Cirrus Logic

DATE: 5-17-94
TO: X3T10 ATA working group
FROM: John Geldman
SUBJECT: 0948dr2.doc comments

These are the comments I have so far from my review of this document.
See you in Harrisburg.

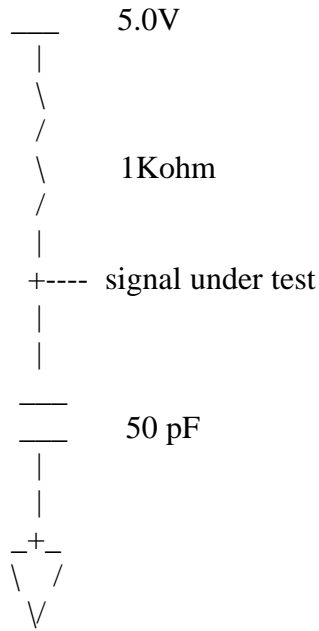
Second, a suggestion for rise and fall (which I had been asked to write). The key concern was when discussing a percentage of full amplitude, just what is full amplitude. The suggested text refers to a relatively slow signal into a well-behaved test circuit. There should not be any significant overshoot or undershoot problems.

Was:

| tRISE | Rise time for any signal on AT interface(1)| 5ns | |
| tFALL | Rise time for any signal on AT interface(1)| 5ns | |

(1) tRISE and tFALL are measured from 0.5V to 2.8V with a resistive load of 1k ohm and a capacitive load of 50 pF.

Suggested:

| tRISE | Rise time for any signal into test circuit(1)| 5ns | |
| tFALL | Rise time for any signal into test circuit(1)| 5ns | |

(1) tRISE and tFALL refer to a voltage change 10-90% of the peak to peak amplitude into a resistive load of 1k ohm and a capacitive load of 50 pF.
